FINAL

**Interim Measures Work Plan
Expanded Bioventing System
SWMU 55 (IRP Site FT-03)**

**Charleston Air Force Base
South Carolina**

April 1997

As-Built Schematic of Pilot Test Vent Well

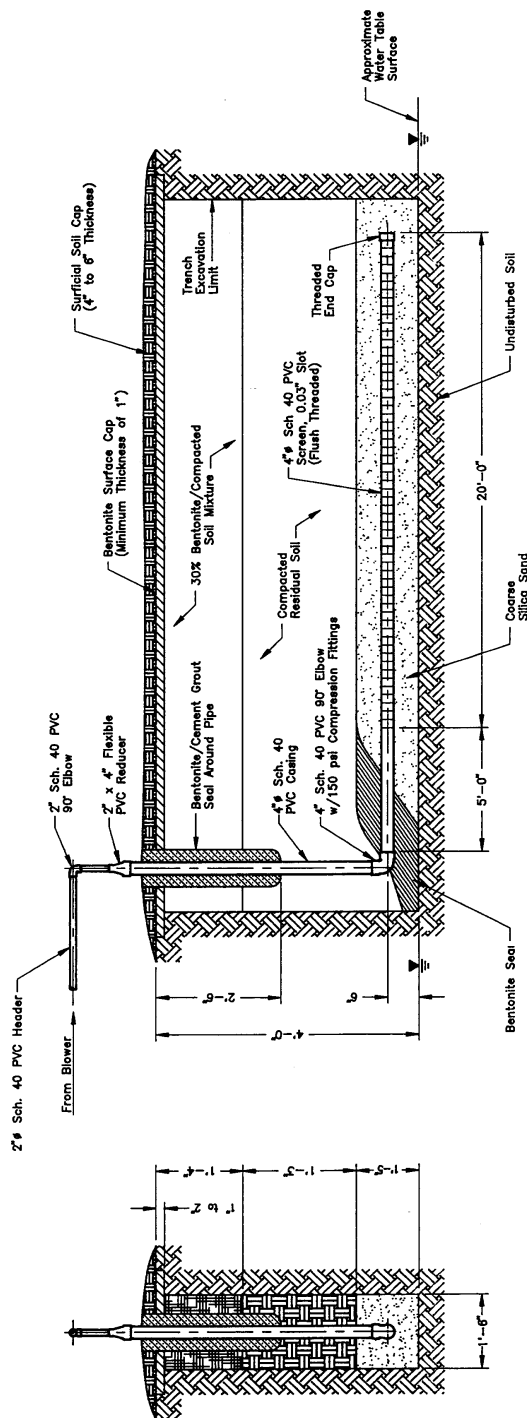
iii) Will the new underground air supply be grouted in place? Figure 3.2 shows the vertical casing exiting the ground surface through a grouted annulus, while Drawing G-0.3 describes a grouted annulus without showing it graphically.

- iii) Figure 3.2 shows an as-built diagram of the existing pilot test vent well. The existing vent well will be retrofitted for below grade completion by removing part of the existing grout seal and attaching a new 2" air injection header pipe. This header pipe will not be grouted in place. Drawing G-0.3 shows the proposed new horizontal vent well. The 4" vertical riser pipe on this well will have a minimum 1-foot bentonite/grout seal. This seal is identified with text on Drawing G-0.3, but the symbol is missing graphically. This seal will be installed and the symbol will be corrected on the as-built drawings.
